APPLICATION NO.	FILING DATE	FIRST NAMED INVENTOR	ATTORNEY DOCKET NO.	CONFIRMATION NO.
18/265,212	06/02/2023	Jonne STEEMAN	D5481.10120US01	6511

Office Action Summary	Application No. 18/265,212	Applicant(s) STEEMAN, Jonne	
	Examiner MARC CARLSON	Art Unit 3723	AIA (First Inventor to File) Status Yes

1. The following is a Final Office Action on the merits.

FIG. 3

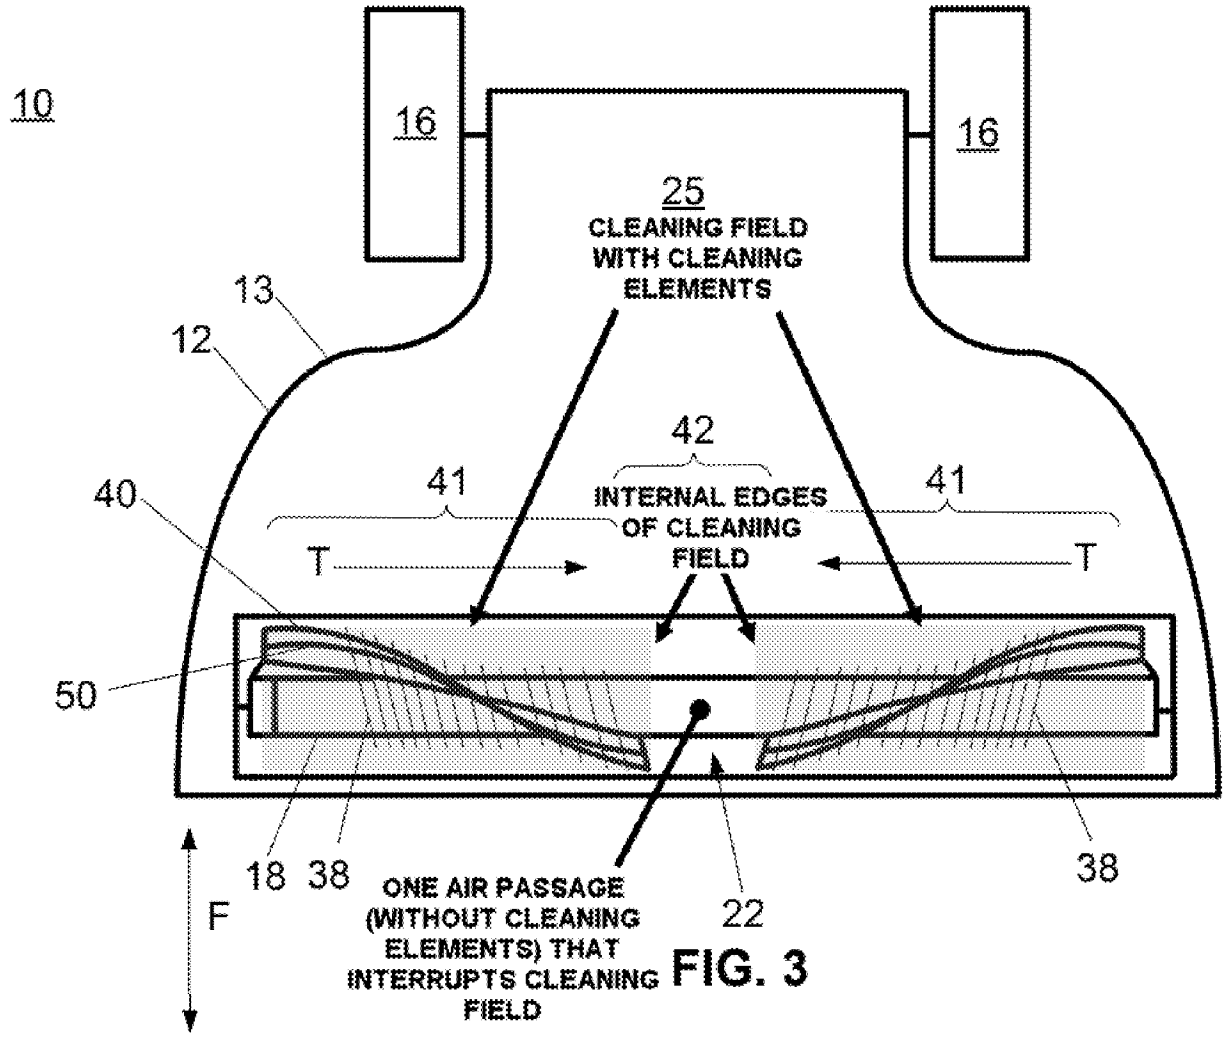
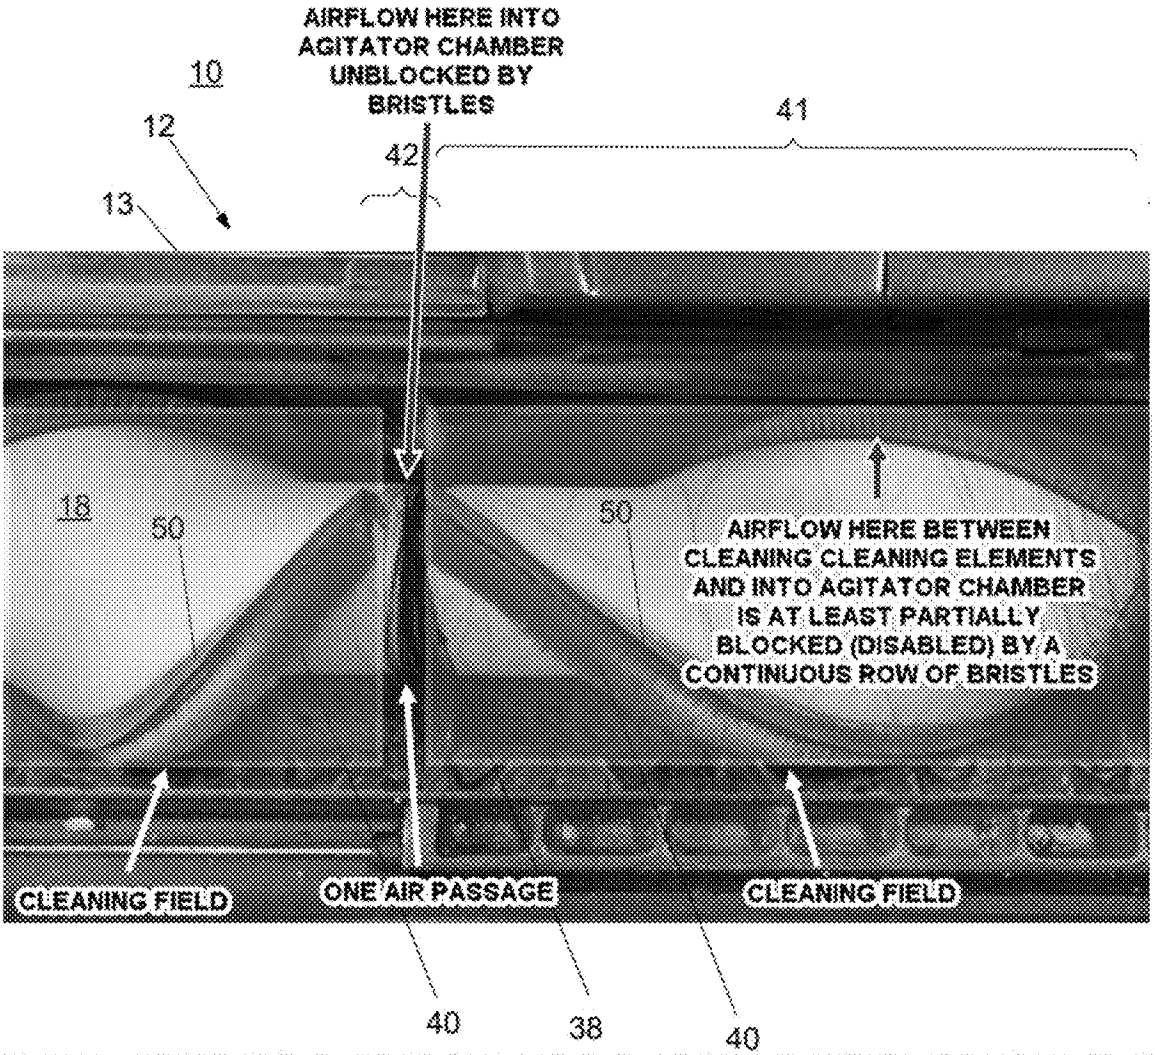
The Examiner respectfully disagrees. In the previous rejection, the Examiner identifies two hair migration portions 41 containing shown in Figure 3 which cite the claimed cleaning field. As shown in Figure 3, the cleaning field includes bristles 40 arranged in continuous rows 46a-n arranged along a length of the agitator in the cleaning field. As shown in Figure 3, the cleaning field is interrupted by at least one air passage (collection area 42) which does not include bristles and spans between the leftmost internal edge of the cleaning field (left hair migration portions 41) and the rightmost internal edge of the cleaning field (right hair migration portions 41). The claim elements, consistent with the original rejection are detailed in the attached Figure 3 below. As shown, Udy discloses that cleaning field is interrupted by at least one air passage configured to enable airflow (without bristle barriers) between internal edges of the cleaning field.
